ENGINEER'S CERTIFICATION

**LOS DURANES
COMMUNITY CENTER**
2920 LEOPOLDO NW, ALBUQUERQUE NM 87104

**GRADING AND
DRAINAGE PLAN
CG-101**

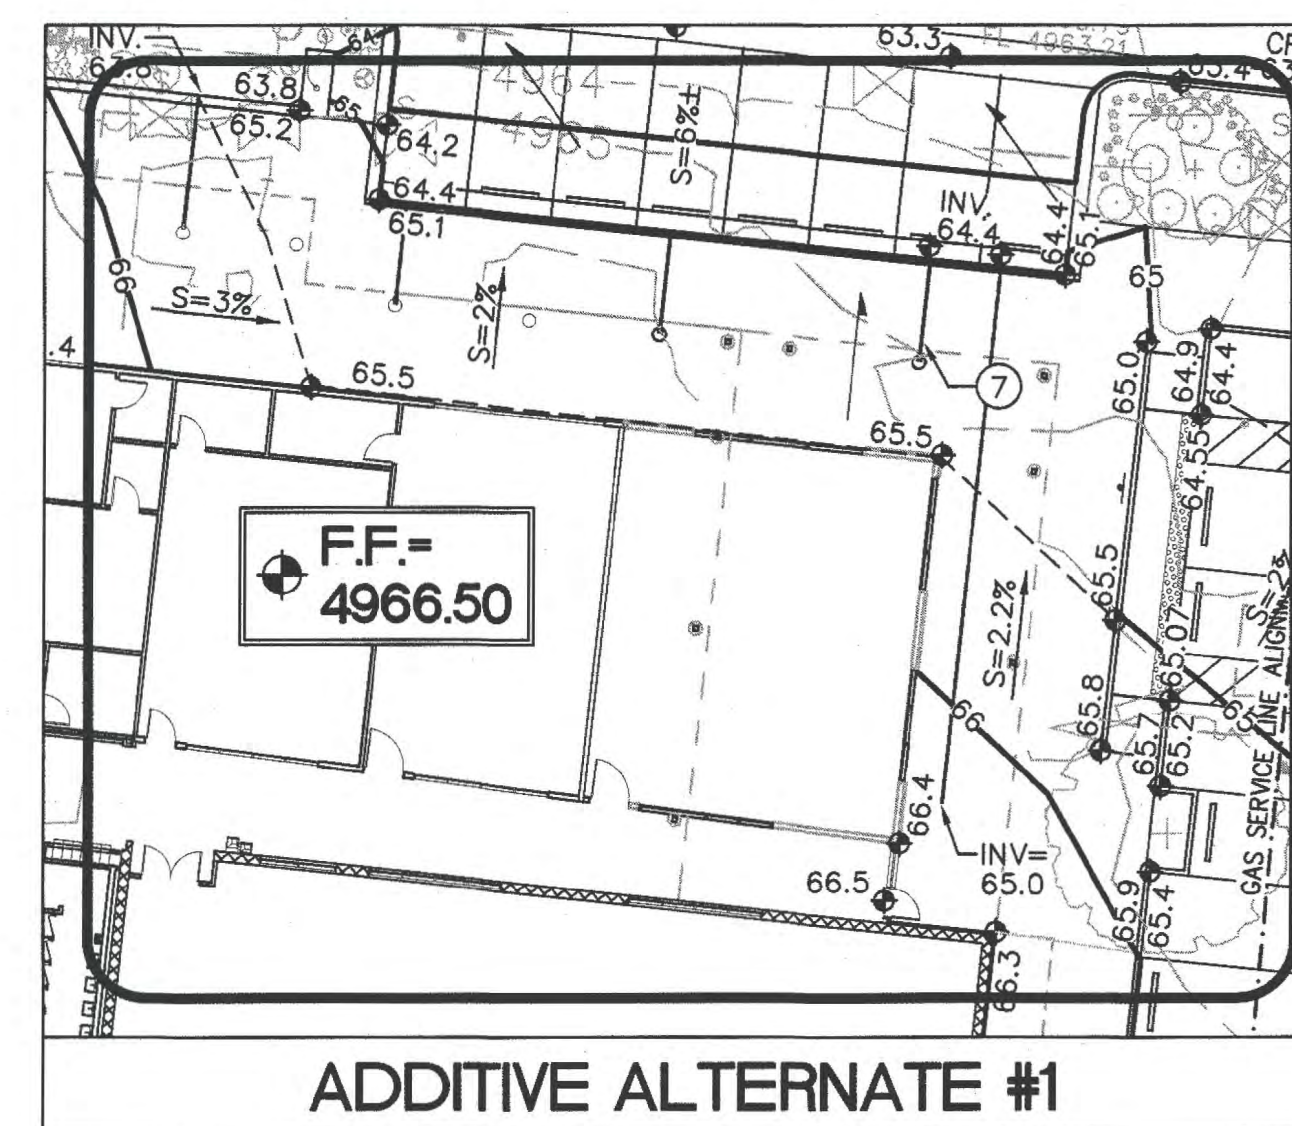
Areas of modification between approved plan and actual as-built:

- △ Parking space not constructed
- △ Alley gutter not constructed
